**Economic Commission for Europe****Inland Transport Committee****World Forum for Harmonization of Vehicle Regulations****Working Party on General Safety Provisions****127th session**

**Amendments to Gas-Fuelled Vehicle Regulation:****UN Regulation No. 110 (Compressed Natural Gas and Liquefied Natural Gas vehicles)****Proposal for Supplement 1 to the 05 Series of Amendments to  
UN Regulation No. 110 (Compressed Natural Gas and  
Liquefied Natural Gas vehicles)****Submitted by the expert from the European Association of Automotive  
Suppliers \***

##### Example 2

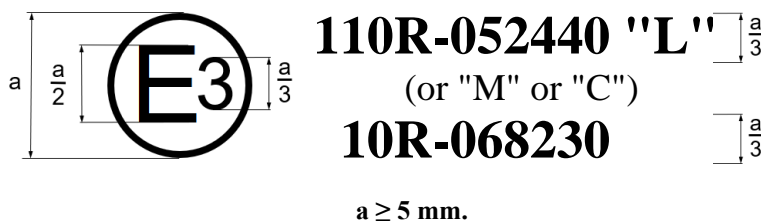
(See paragraph 7.4.3. of this Regulation)

This approval mark when affixed to the CNG and or LNG component shows that this component has been approved in Italy (E 3), pursuant to UN Regulation No. 110 under approval number 052440 and pursuant to UN Regulation No. 10<sup>1</sup> under approval number 068230. The first two digits of the first approval number indicate that the approval was granted in accordance with the requirements of UN Regulation No. 110 as amended by the 05 series of amendments.

**The first two digits of the second approval number indicate that the approval was granted in accordance with the requirements of UN Regulation No. 10 as amended by the 06 series of amendments."**
